CERTIFICATE OF APPROPRIATENESS

Property: 909 Texas Avenue, Lots 1, 2, 6 through 10 & 12 and Tracts 3A & 11A, Block 57, SSBB Subdivision. The property includes a historic, brick, 518,000 square foot 18-story former hotel building situated on a 45,000 square foot corner lot.

Proposal: Alteration – Replace existing non-original Texas Street entry doors and alter 110 window openings on floors 3-16.

Recommendation: Partial Approval: Approval of window alterations; Denial of alterations to Texas Street entry

SOUTH ELEVATION ENTRY DETAIL – FRONT FACING TEXAS STREET

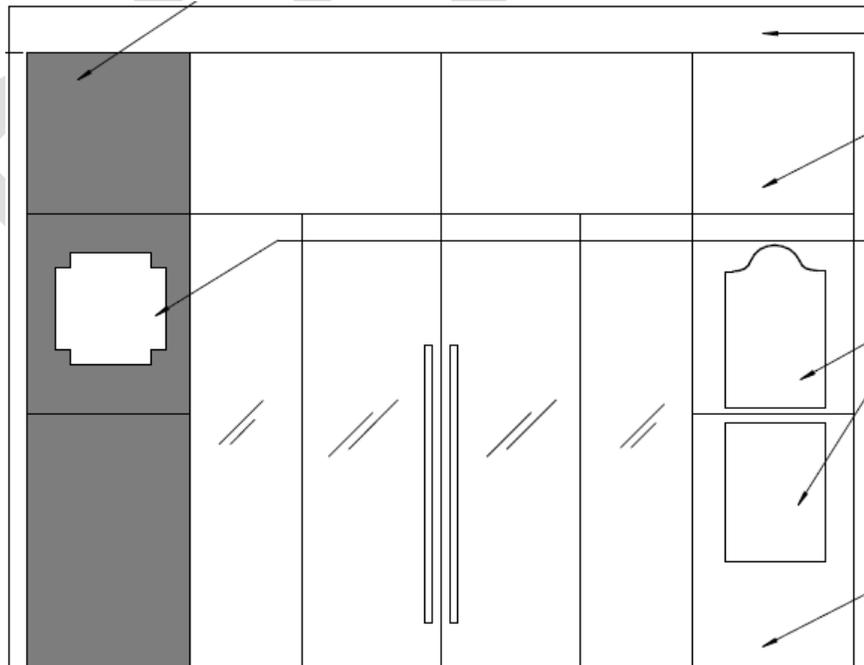
<i>The primary entrance into the building is a significant aspect of its character, and the proposed alterations create a contemporary entry that is not in keeping with the building's historical character.</i> |

<i>The proposed alterations create a contemporary entry that is not in keeping with the building's historical character.</i> |

<i>The relationship of solids to voids in the ground level storefronts creates a rhythm that ties the blockface together and links the building to the rest of the district. The proposed entry, with its large expanse of frameless glass, disrupts that rhythm.</i> |

<i>Though the individual materials themselves may be appropriate, an unbroken expanse of glass for the Texas Street entry uses the material at a scale incompatible with its use elsewhere on the structure.</i> |

<i>Though the existing entry doors are not original, they are of an appropriate character for this building. A frameless glass entry is not appropriate.</i> |

<i>Though the existing entry doors are not original, they are of an appropriate character for this building. A frameless glass entry is not appropriate.</i> |
